**JACKSON HEIGHTS SUBDIVISION, UNIT 5,**  
**RESUBDIVISION OF LOTS 1 & 2,**  
**RESUDIVISIOIN OF LOT 8**

APPLICATION NUMBER 16 DATE February 18, 2010

REQUEST Subdivision

# DETAIL SITE PLAN

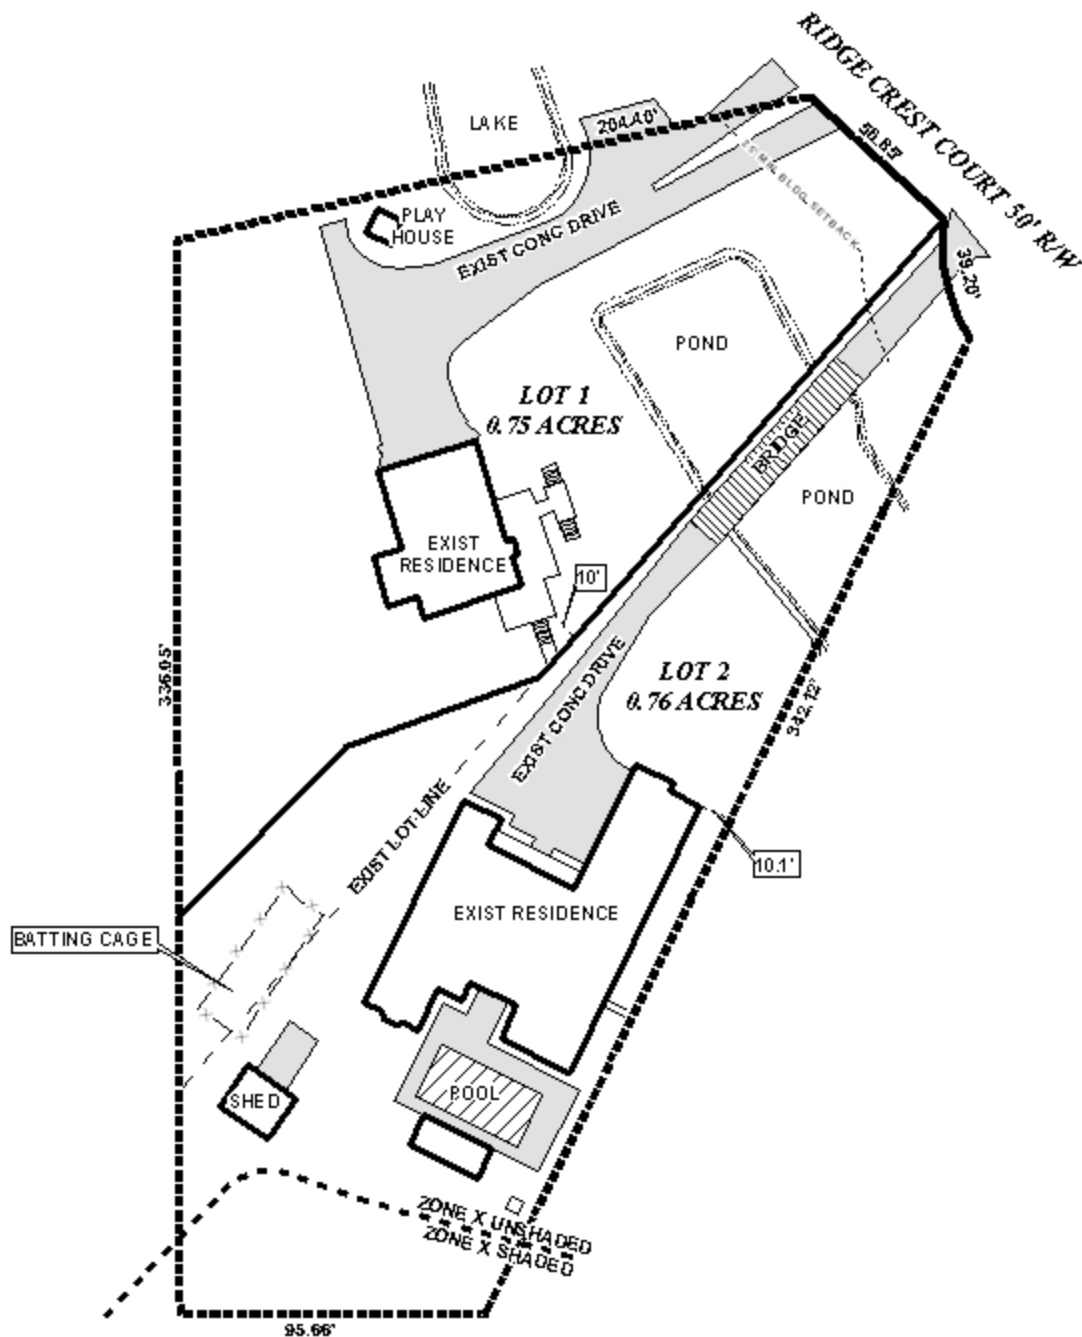
The minimum building setback line is depicted on the preliminary plat, however, the minimum building setback line should be relocated on Lot 2, to where the lot is at least 60-feet in width. Relocation of the setback line for Lot 2 is to ensure compliance with Sections V.D.2. and V.D.9. of the Subdivision Regulations.

The proposed lots do not comply with width to depth ratio of Section V.D.3. of the Subdivision Regulations. As the proposal is to modify two existing legal lots, a waiver of Section V.D.3. may be appropriate for the application.

- 2) Revision of the minimum building setback line to be located a minimum of 25-feet from the right-of-way, and where the lots are at least 60 feet in width, to comply with the requirements of Sections V.D.2. and V.D.9. of the Subdivision Regulations;
